CO-OP MINING COMPANY

RE: 9/9/86 Letter - Hiawatha  
Seam Revision

Co-Op Mining Company requests a partial approval of the Hiawatha Seam Revision, Bear Canyon Mine, ACT/015/025, July 14th 1986 Revision.

#### 7.2.5.2.0 ADDITIONAL CONTROL FOR HIAWATHA SEAM MINING

Figure 7-F1

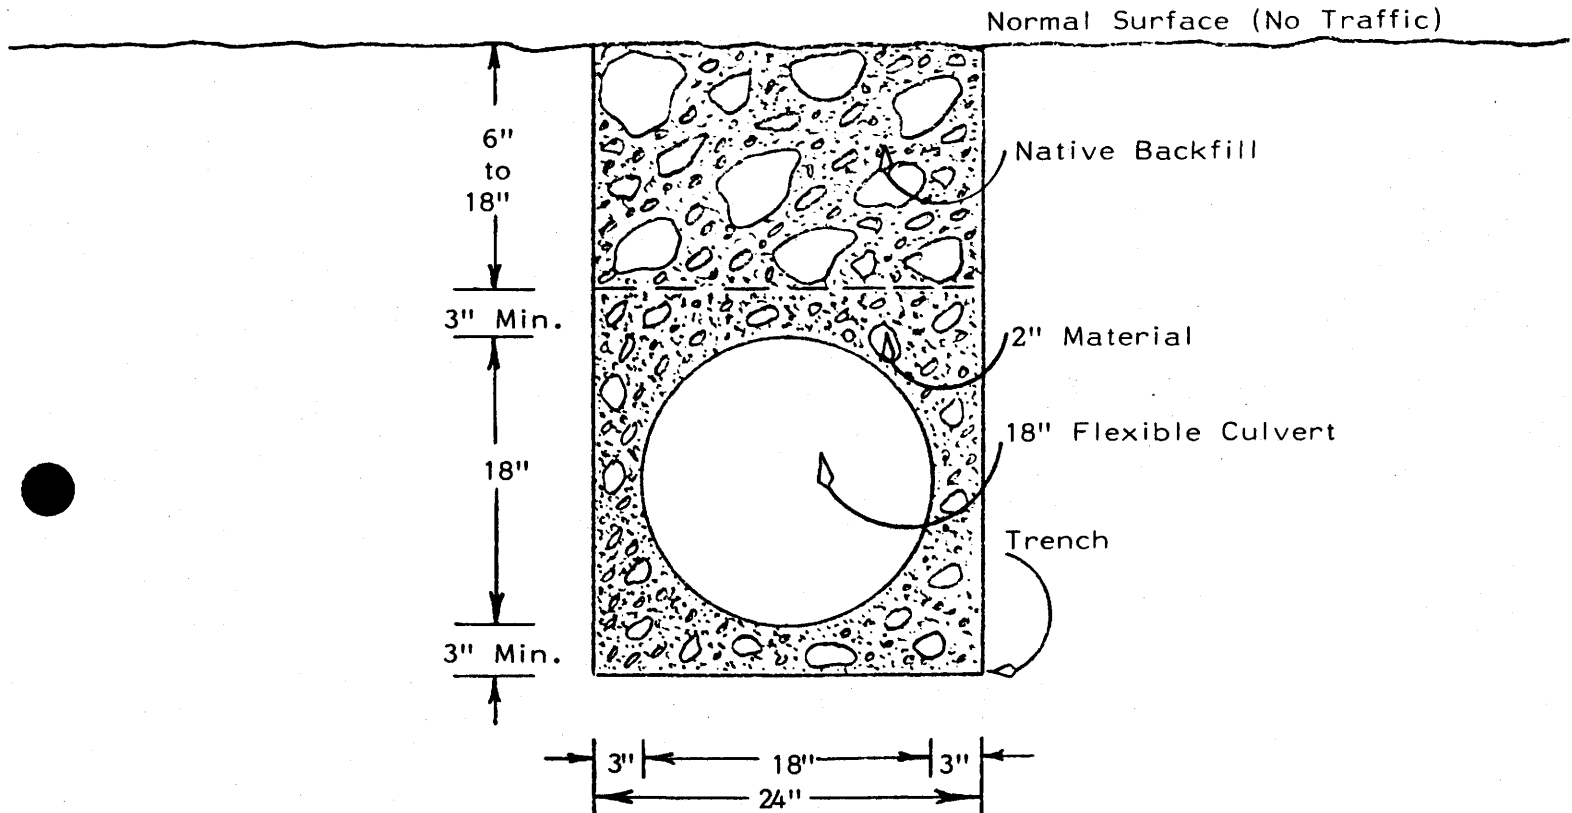
As shown on Plate 2-2, the outslope of the proposed Hiawatha Seam portal pad will encroach upon the ephemeral channel between D-1D and d-2D on Plate 7-8. It is proposed to install a 15" flexible culvert as shown in Figure 7-F1 and 7-F2 to convey the drainage from the upper areas of the channel beneath the pad. The outlet protection for the flexible culvert shown on Plate 2-2 will adhere to the specifications as indicated on pages 83-B3, B4 and page 64A Bear Canyon MRP. The rip-rap and filter blanket specification will be adhered to as specified.

The pad and channel will be constructed prior to placing the flexible culvert in the excavated channel. The culvert will be backfilled and all heavy equipment will be precluded from the area to avoid an accidental crushing of the buried culvert. The flexible culvert is designed to withstand being buried but will not hold up under

heavy equipment traffic. This channel is included in drainage area AD-1 (Plate 7-5). The maximum water this channel is calculated to flow is shown on Table 7.2-8 as 1.5 cfs (Ditch D-2D). Calculations for this ditch are shown in Appendix 7-F under Runoff Ditch Sizing. Based on this flow, the culvert is sized as shown on Table 7.2-7 (Revised Summary of Culvert Sizes). The new culvert is designated C-4D, and matches the criteria for culvert C-1D. The headwater depth above the top of the culvert inlet is proposed to be 1' more than adequate to carry the expected flow. Energy dissipators will be placed as indicated in the following sections (7.2.5.2.1 and 7.2.5.2.2)
